Studebaker

SERVICE BULLETIN

NO. 244

1950

GAGE FOR ACCELERATOR LINKAGE ADJUSTMENT - AUTOMATIC DRIVE

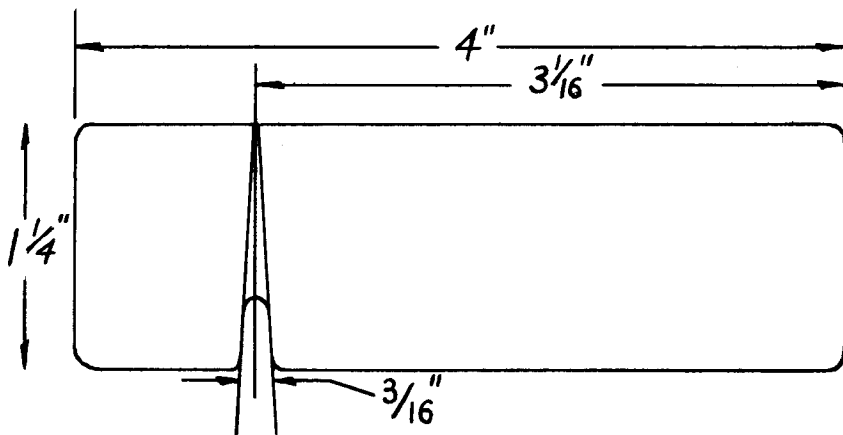
In making the accelerator-to-transmission control linkage adjustment given in Service Bulletin No. 241, page 2, it is necessary to make an exact measurement of 3-1/16" between the firewall and the center of the clevis pin at the accelerator cross shaft, when the accelerator is in the fully released position.

To assure accuracy and also save time in making this adjustment, a gage can be made in the shop which will eliminate the need of reading the small graduations on a steel scale. The illustration accompanying this article is full scale and can be used as a template. Make the gage from a piece of 1/8 inch steel stock 1-1/4 in. x 4 in. The slot in the gage is designed to fit over the clevis pin and the other end of the gage should butt flush against the firewall when the adjustment is correct.

CHANGING REAR AXLE RATIOS - 2R5, 2R6

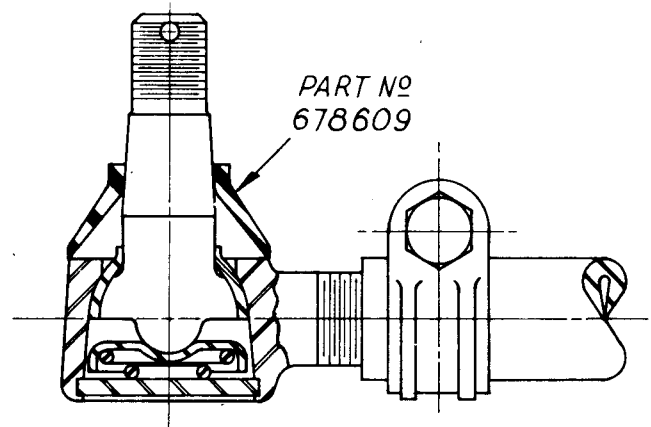
When changing the rear axle ratio of 2R5 or 2R6 model trucks from 4.82 to 4.09 or vice

versa, it is necessary to change the differential case in order to provide proper clearance for the ring gear and pinion used.

The differential case for the 4.09 ratio (Part No. 523660) has the ring gear mounting surface 2-7/32" from the hub end of the case (see drawing). The differential case for the 4.82 ratio (Part No. 195117) has the ring gear mounting surface 2-13/32" as indicated in the drawing.

1 - 516456 Gear and Pinion
1 - 523660 Differential Case

1 - 190030 Gear and Pinion
1 - 195117 Differential Case

STEERING TIE ROD END COVER - 2R5, 2R6, 2R10, 2R11, 2R14, 2R15, M5, and M15

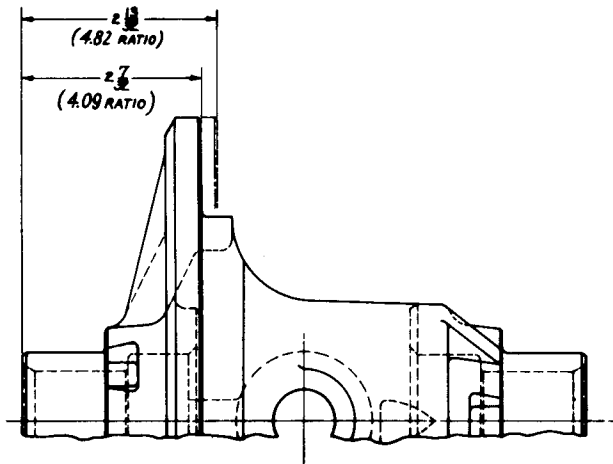
Effective with Serial Nos. R5-62866, R6-923, R10-27127, and R11-941, a one-piece rubber seal that fits tight around the tie rod end and ball stud entered production. This rubber cover (see illustration) seals out dirt and abrasive and supersedes the former metal-and-rubber seal formerly used.

The new seal can be used on any of the above model trucks by removing the original seal. It is similar to the seal now in use on 2R16A and 2R17A models.

The new part is available for service use on 2R5, 2R6, 2R10, 2R11, 2R14, 2R15, M5, and M15 trucks. Order through your nearest parts depot, specifying Part No. 678609, Tie Rod Ball Cover. Two covers are used on each vehicle.
